SUBJECT: Top Loader Unbalanced During Spin Cycle

SERVICE BULLETIN	
PRODUCT:	Washing Machine
BULLETIN NUMBER:	ASC20150605001
BULLETIN DATE:	6/5/2015
MODELS:	WA400,WA422, WA456,WA45H7000, WA45H7200

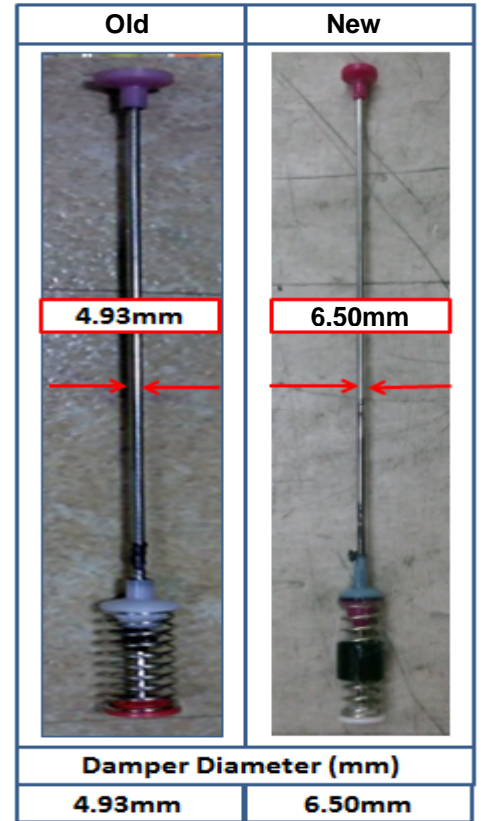
- UE/DC Error Displayed
- Unit unbalanced during spin cycle

If the unit displays Unbalance or a DC/UE Error, you must install the **New ASSY DAMPER (DC97-05280W)**.

❖ **You must order 4 new ASSY Dampers, one for each corner of the washer.**
